ORIGINATION FORM

Proposed Revisions to a Standard Plans Index

Index Number: 700-110

Index Title: MOUNTING EXIT NUMBER PANELS TO SIGNS

LAST REVISION 11/01/23	REVISION	DESCRIPTION:	 FY 2024-25 STANDARD PLANS	MOUNTING EXIT NUMBER PANELS TO SIGNS	INDEX 700-110	SHEET 1 of 1
---------------------------	----------	--------------	--	--------------------------------------	------------------	-----------------

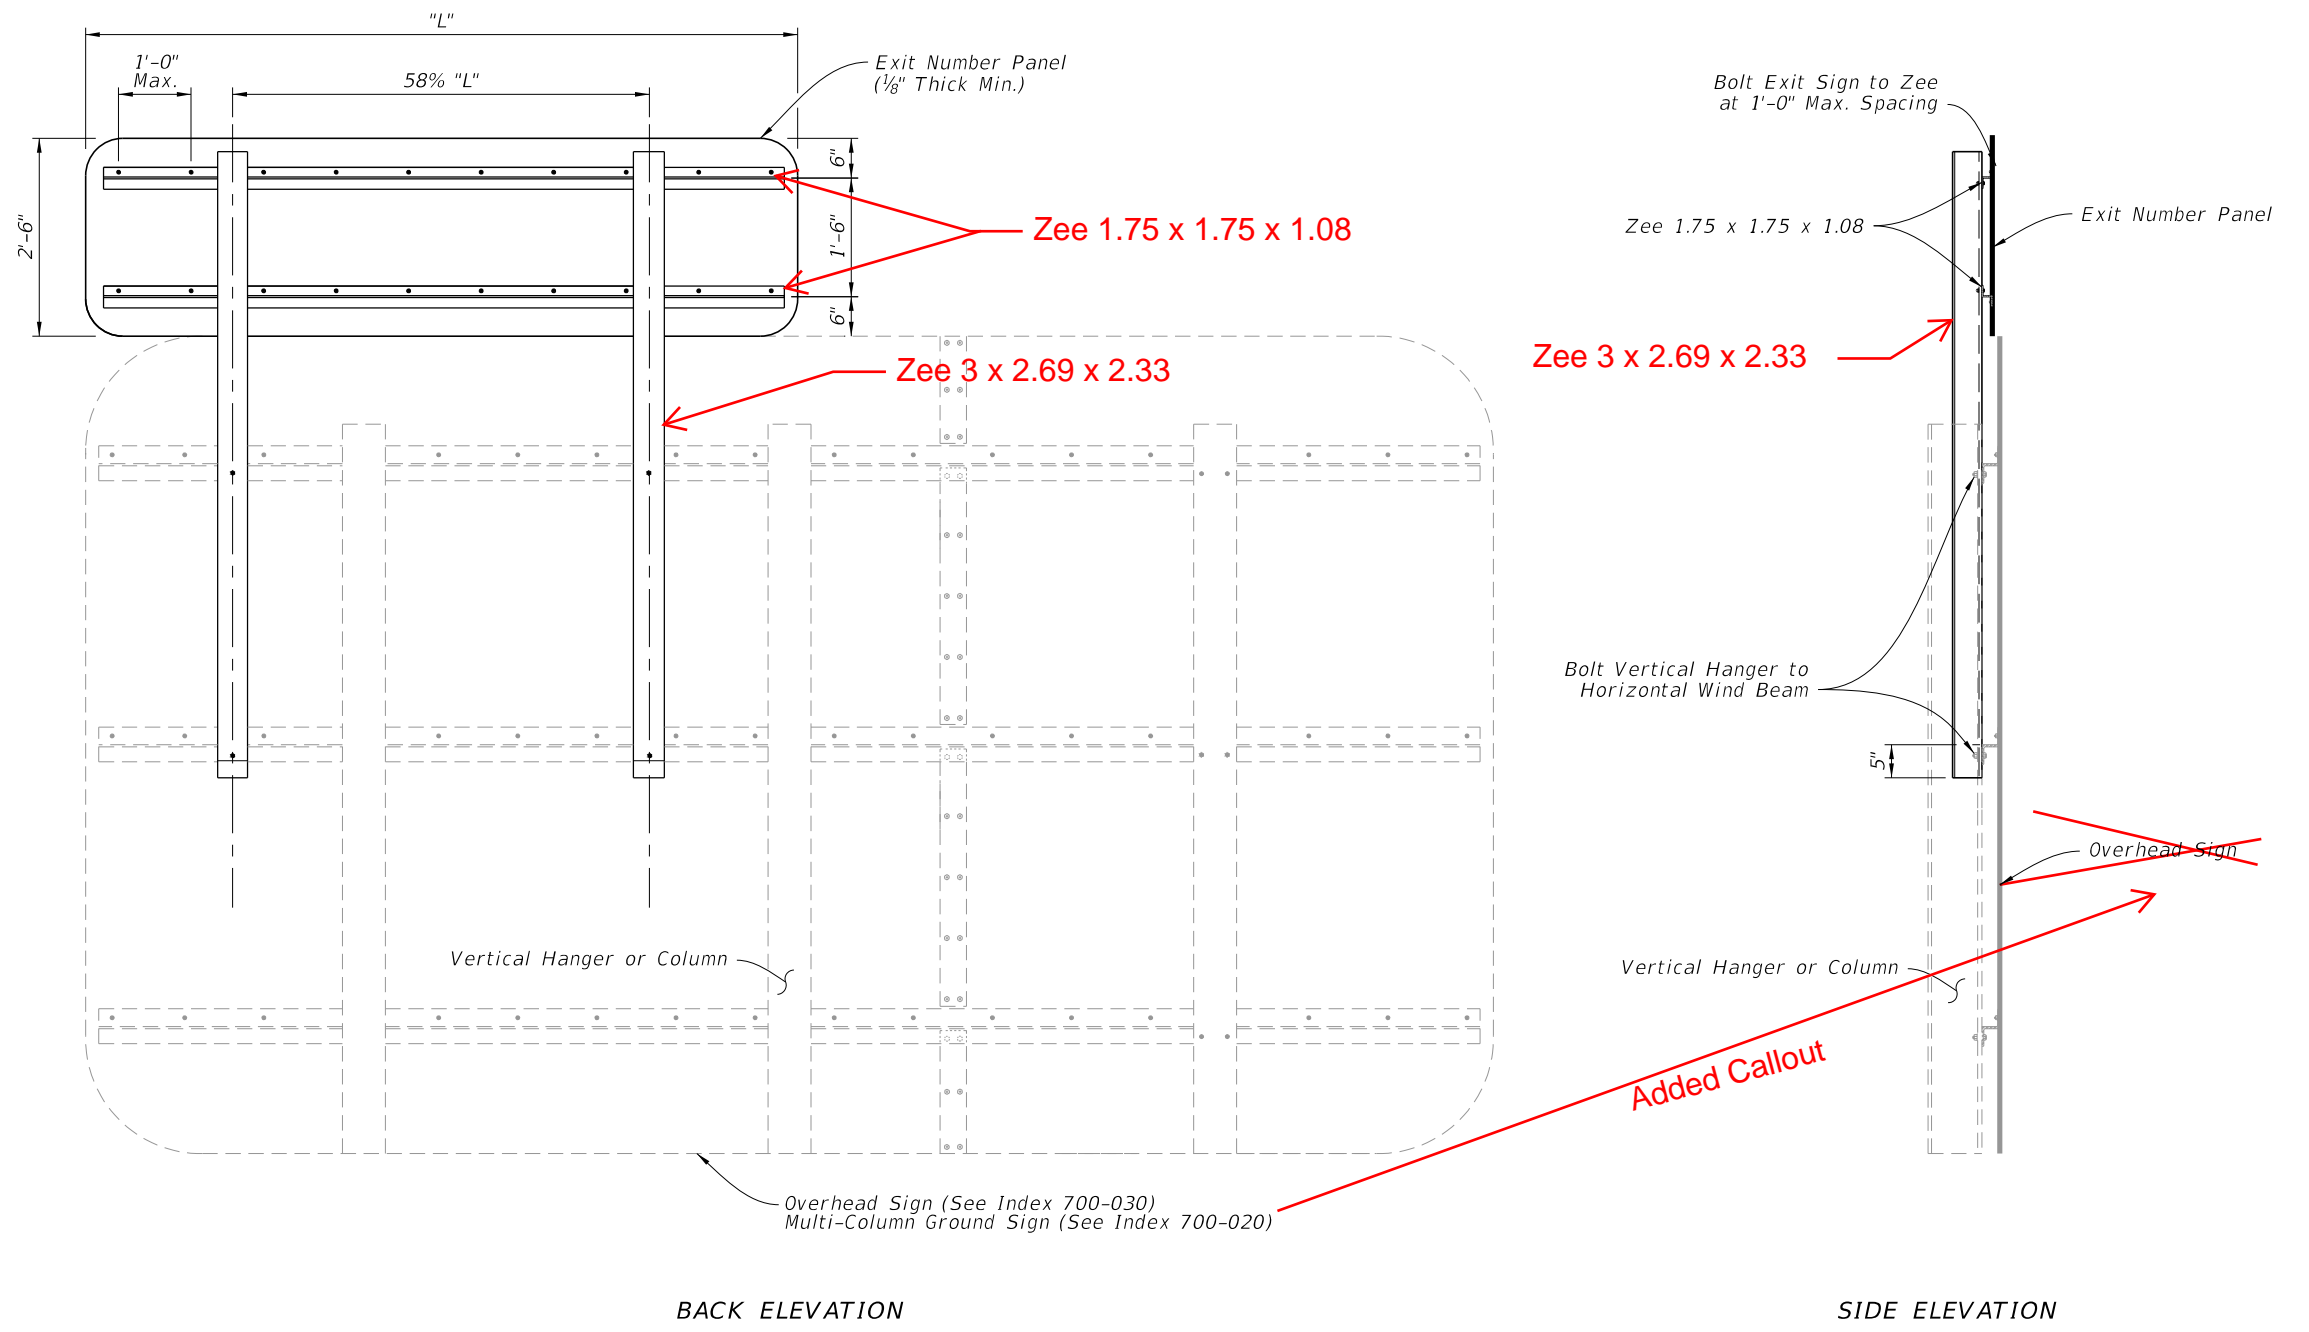
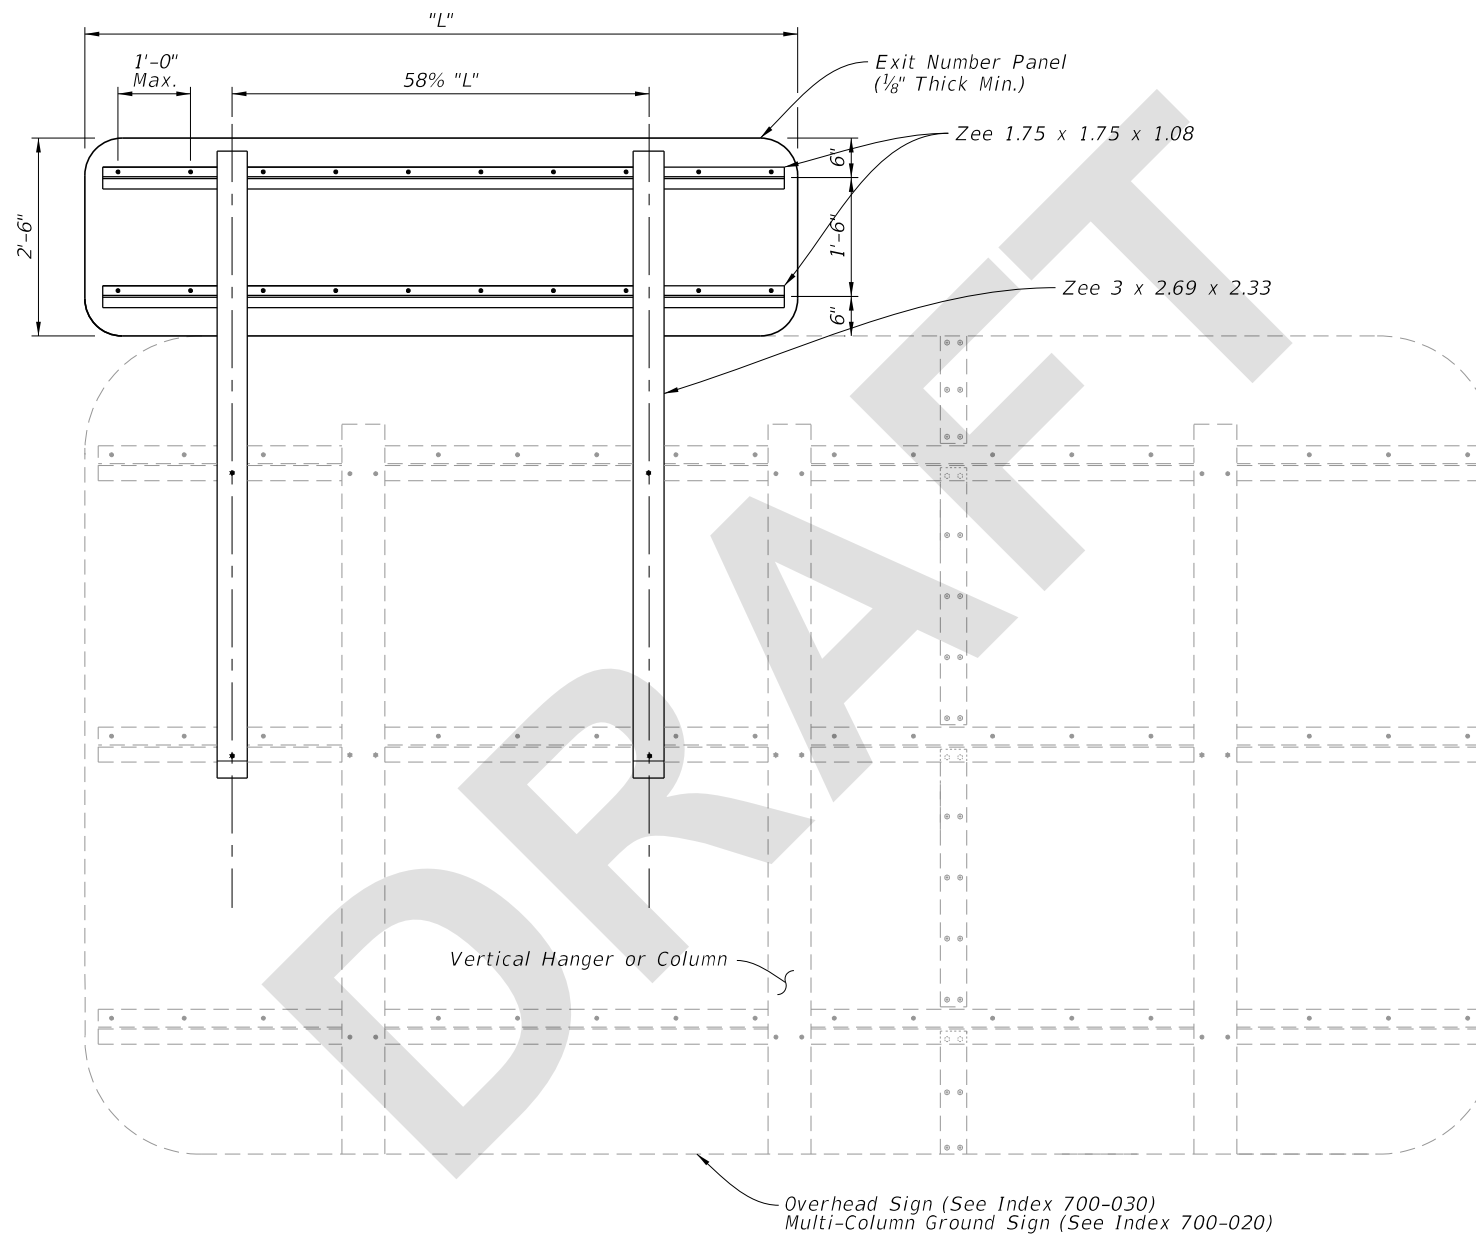
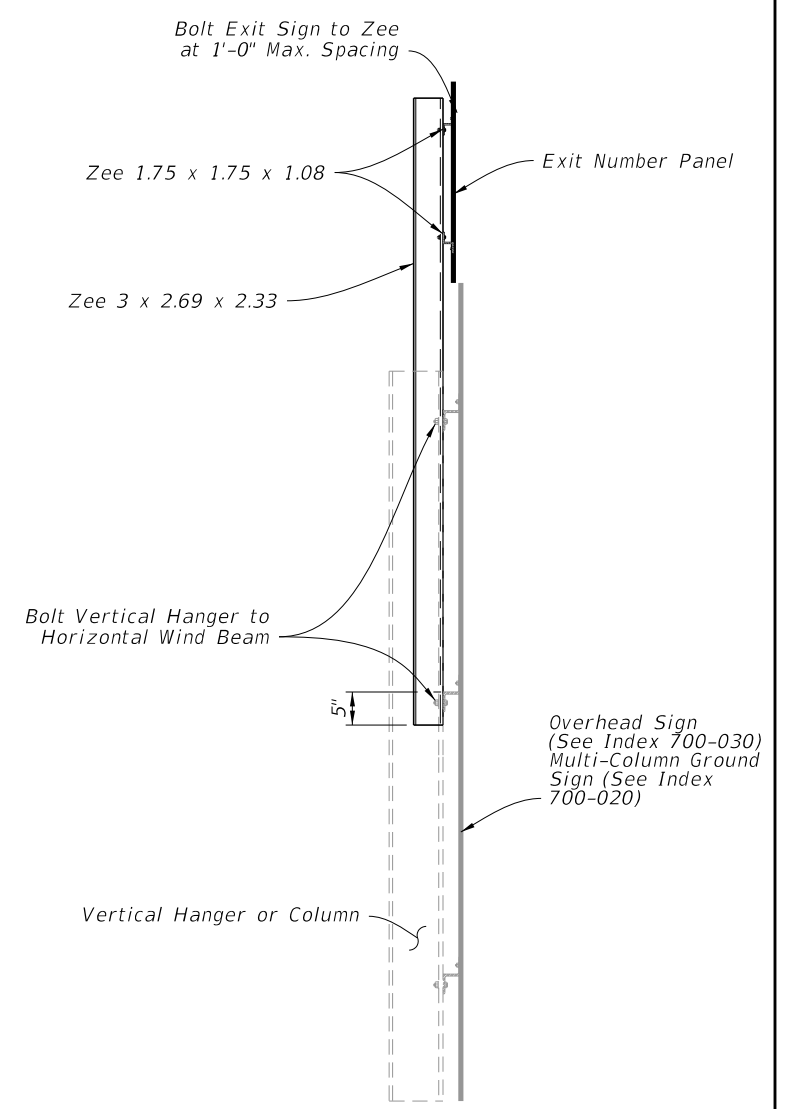
Sheet 1: Added missing callout; Added additional callouts for clarity.

This Standard was modified around 2018 and a callout was not copied over as required. We added the missing callout and made some minor callout changes for clarity.
